Prairie Island Nuclear Generating Plant Units 1 and 2
Dockets 50-282 and 50-306
License Nos. DPR-42 and DPR-60

License Amendment Request (LAR) to Revise the Spent Fuel Pool Criticality Analyses and Technical Specifications (TS) 3.7.17, "Spent Fuel Pool Storage" and 4.3, "Fuel Storage"

License Amendment Request (LAR) to Revise the Spent Fuel Pool Criticality Analyses and Technical Specifications (TS) 3.7.17, "Spent Fuel Pool Storage" and 4.3, "Fuel Storage"

FIGURE 4.3.1-9 Spent Fuel Pool Checkerboard Region Burnup and Decay Time Requirements—OFA Fuel, 12 GAD

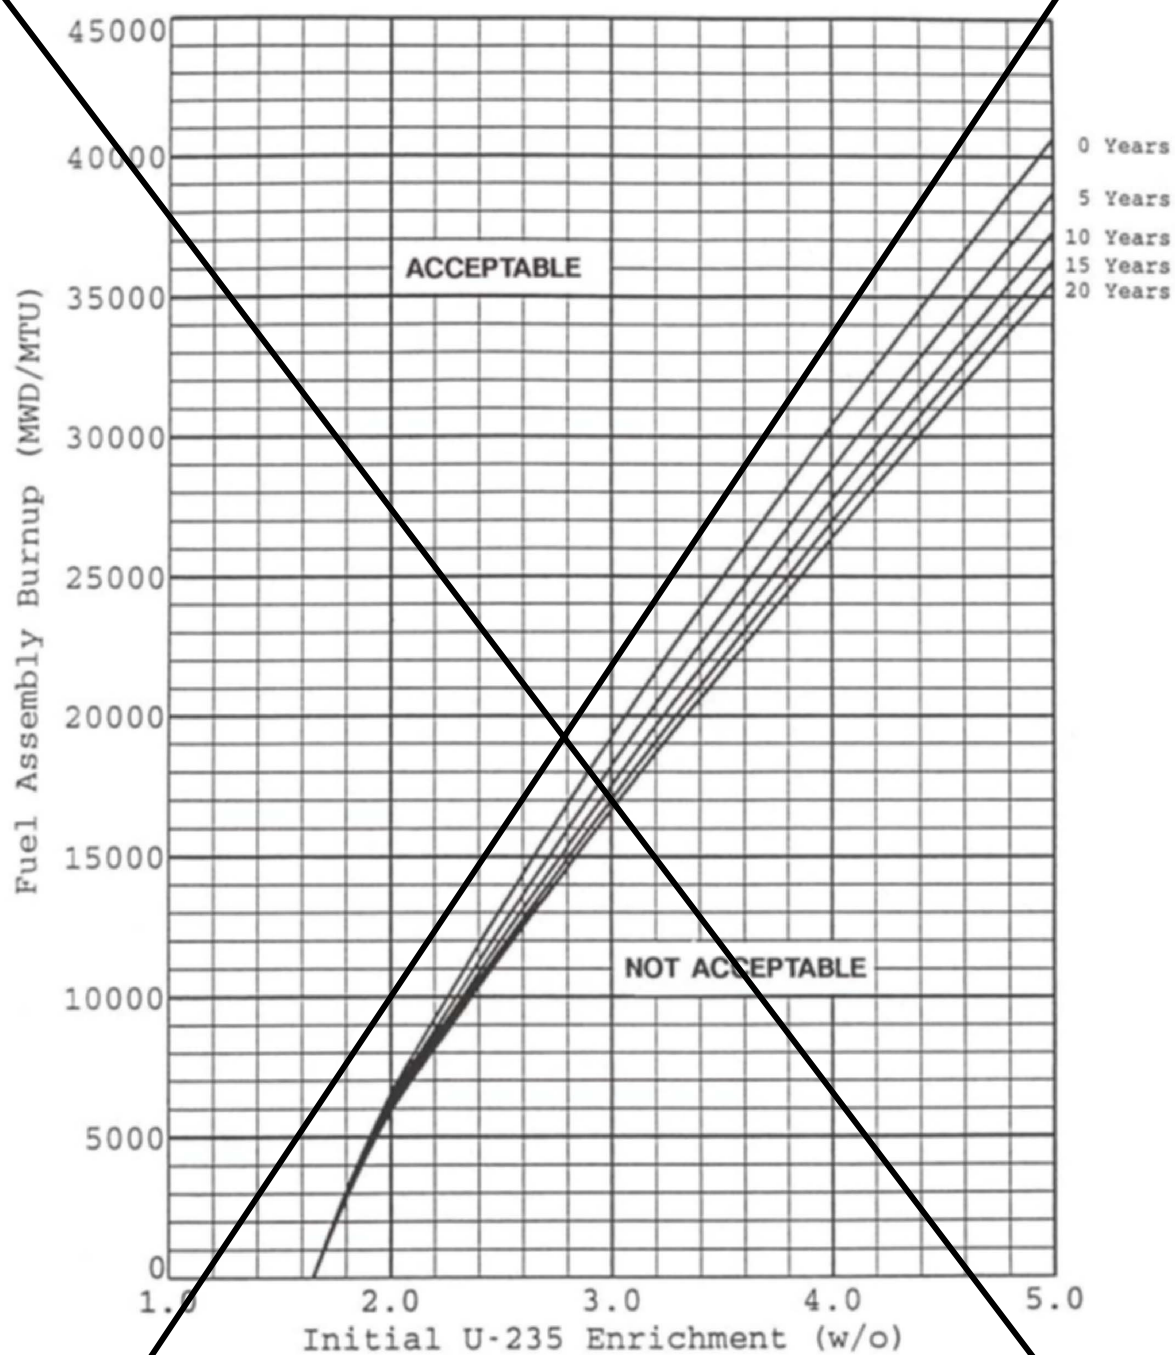
Figure deleted

FIGURE 4.3.1-10 Spent Fuel Pool Checkerboard Region Burnup and Decay Time Requirements—STD Fuel, 12 GAD

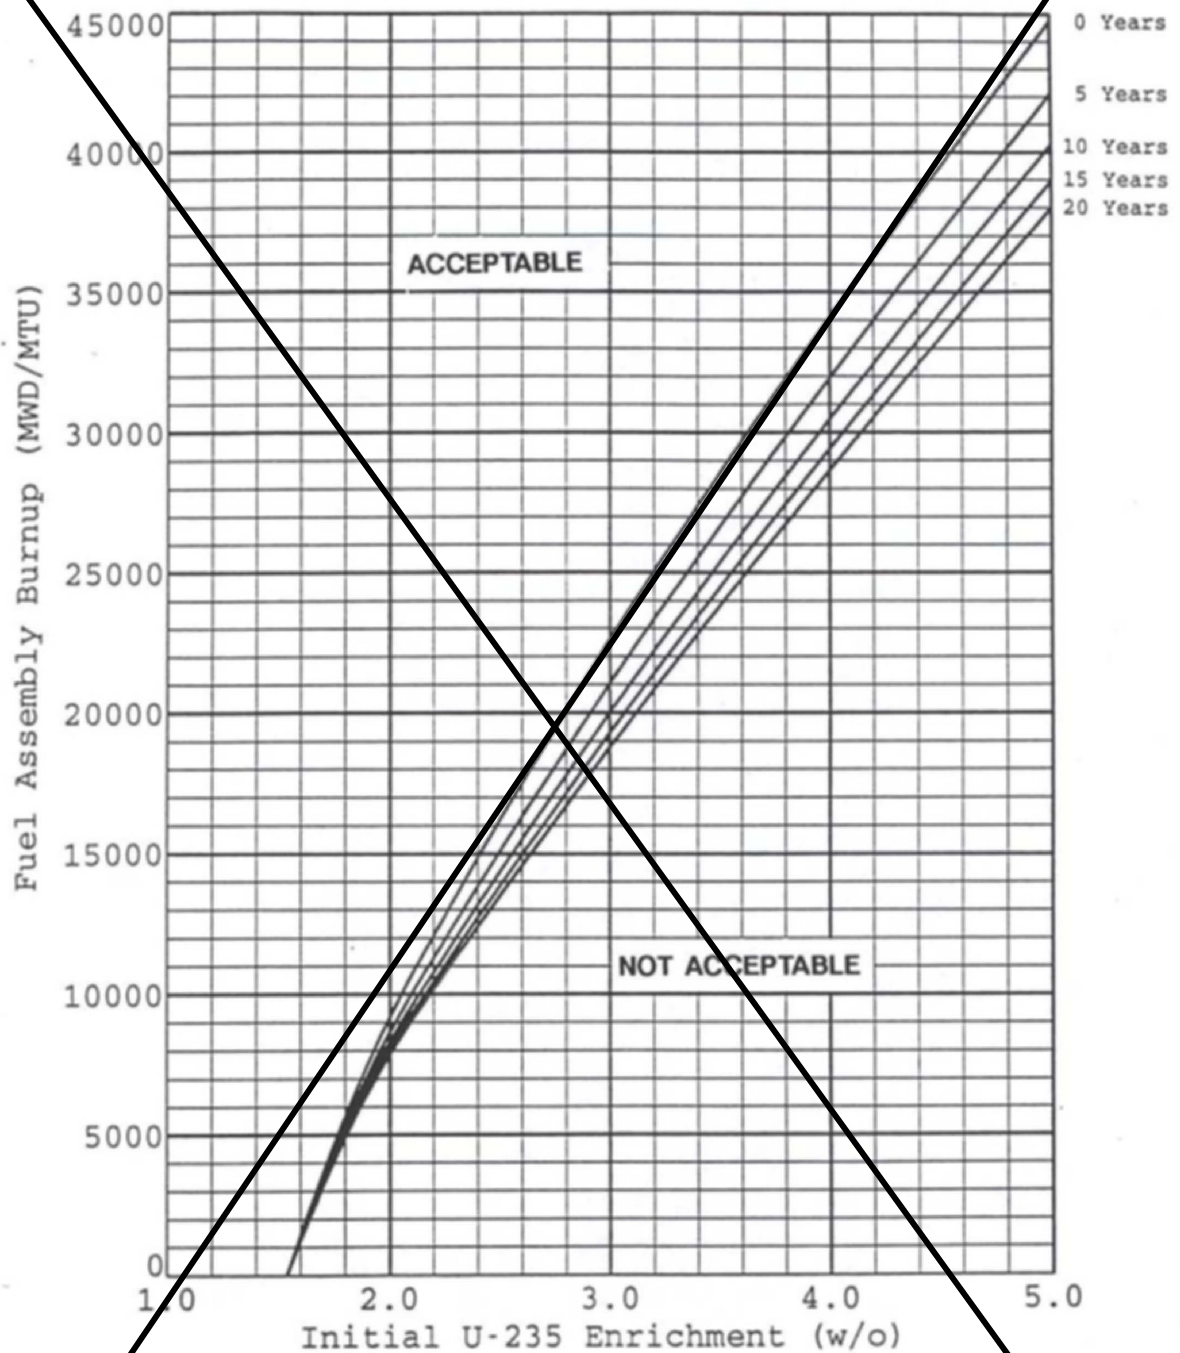
Figure deleted

FIGURE 4.3.1-11 Spent Fuel Pool Checkerboard Region Burnup and Decay Time Requirements—OFA Fuel, 16 or More GAD

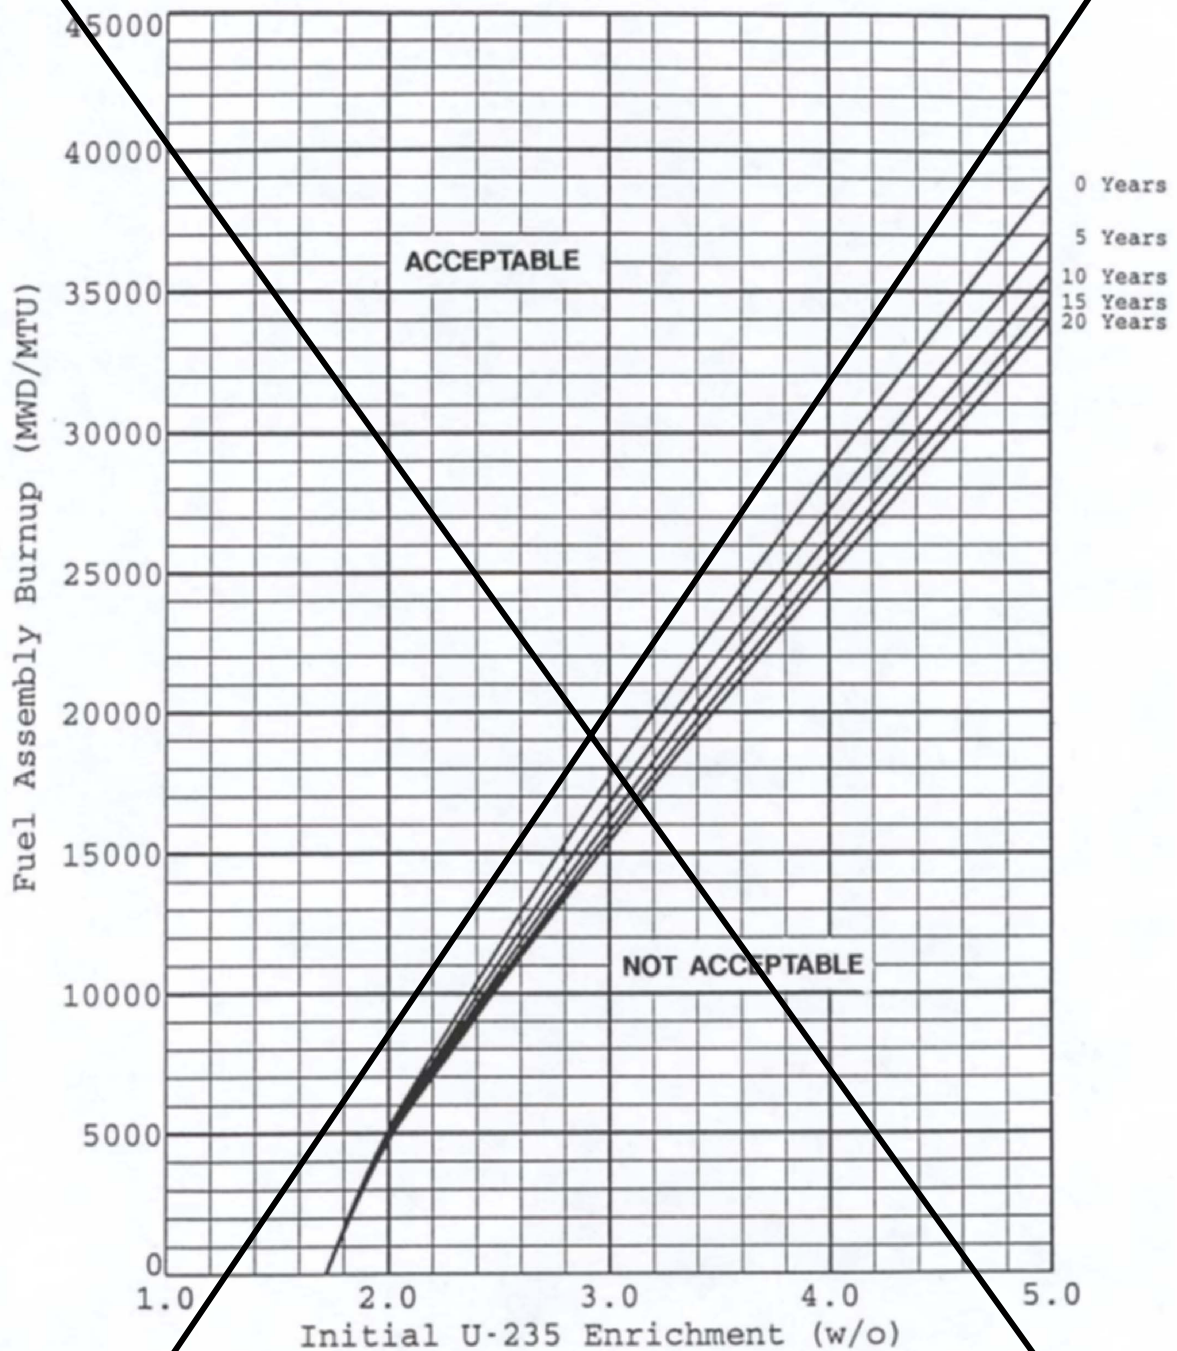
Figure deleted

FIGURE 4.3.1-12 Spent Fuel Pool Checkerboard Region Burnup and Decay Time Requirements—STD Fuel, 16 or More GAD

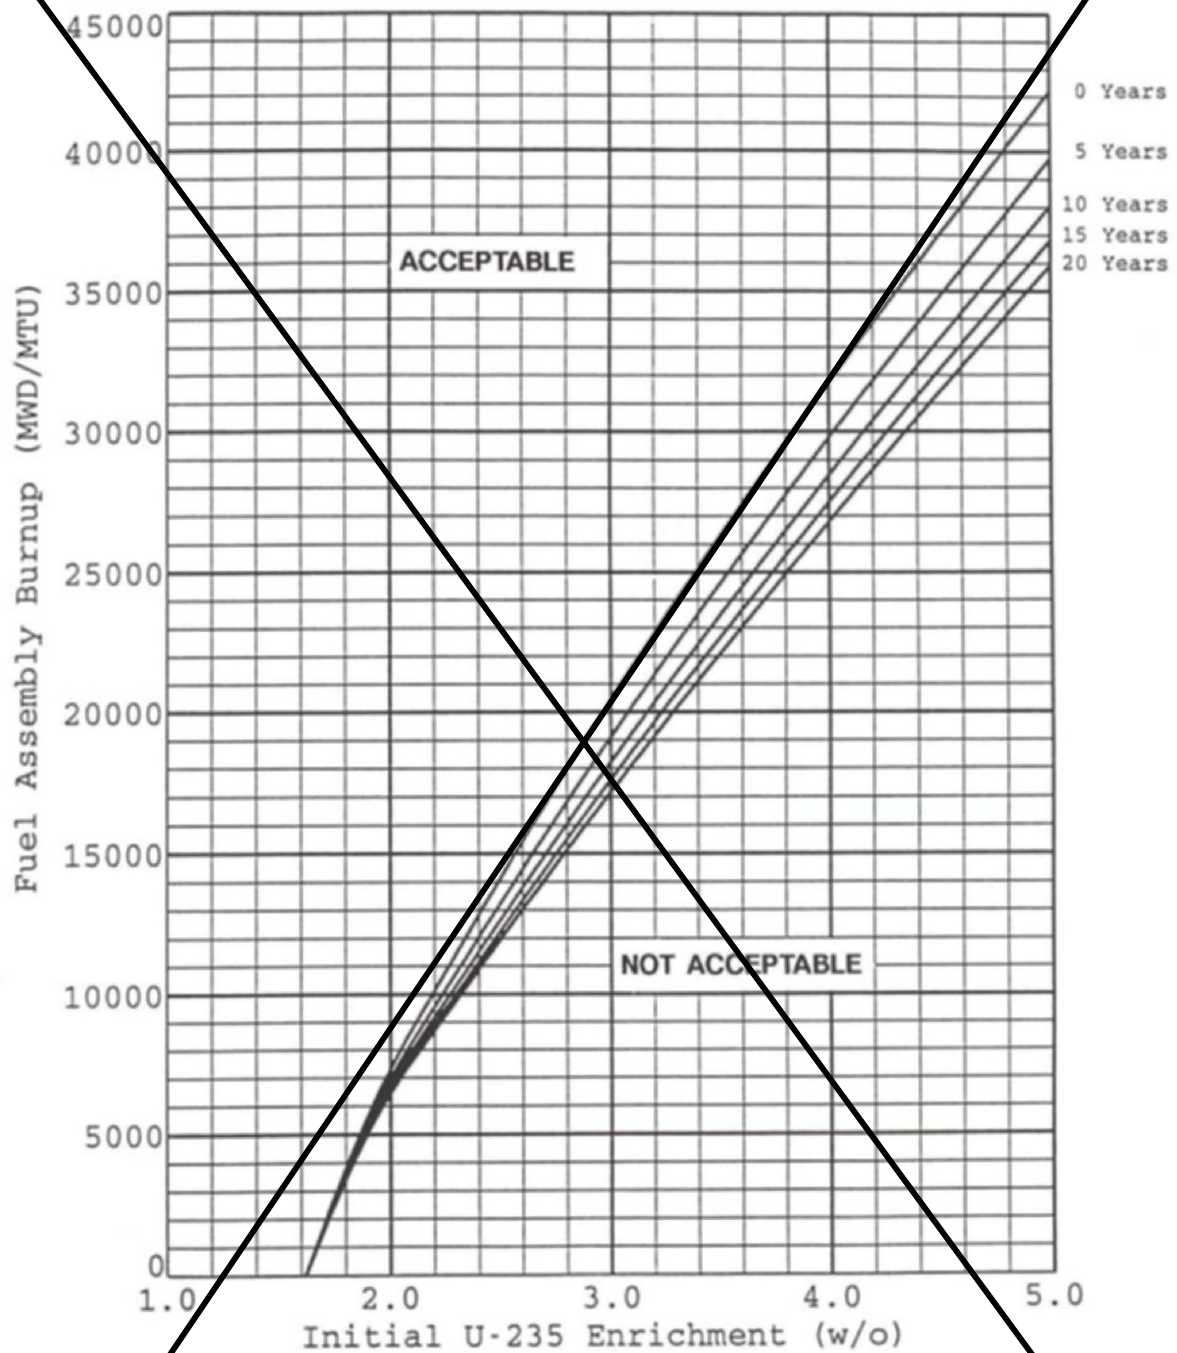
Figure deleted
